**MUNICIPALITY OF LEAMINGTON
DRAINAGE FACILITY STUDY
B & C PUMPING STATION**

January 2007
Project No. 161001259.201

Figure 4-11

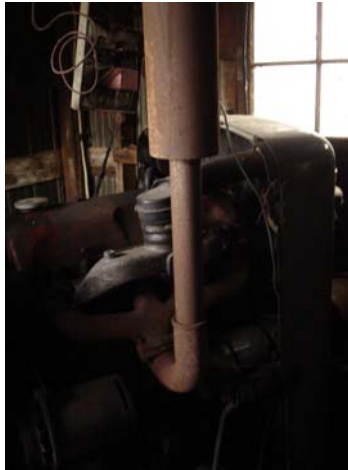
Burn hazard on diesel engine exhaust as can be seen in Figure 4-11.

Suitably insulate diesel exhaust stack and muffler to prevent burn hazard. However, we recommend giving this deficiency no further consideration since the diesel driven pump is no longer in use.

Figure 4-13

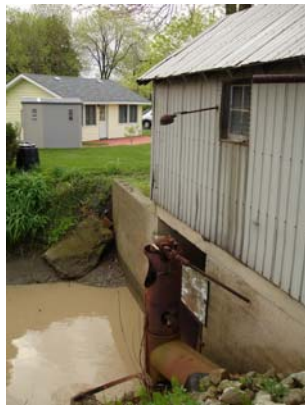
Guardrail was lacking for the fall hazard into water. Refer to Figures 4-13 & 4-14 for examples.

Install suitable guardrail and where a worker is exposed to the hazard of falling into liquid that is of sufficient depth for a life jacket to be effective as protection from the risk of drowning, there shall be an alarm system and rescue equipment, appropriate in the circumstances, to ensure the worker's rescue from the liquid and,

- (a) the worker shall wear a life jacket; or

- (b) the employer shall develop written measures and procedures to prevent the worker from drowning and shall implement them.
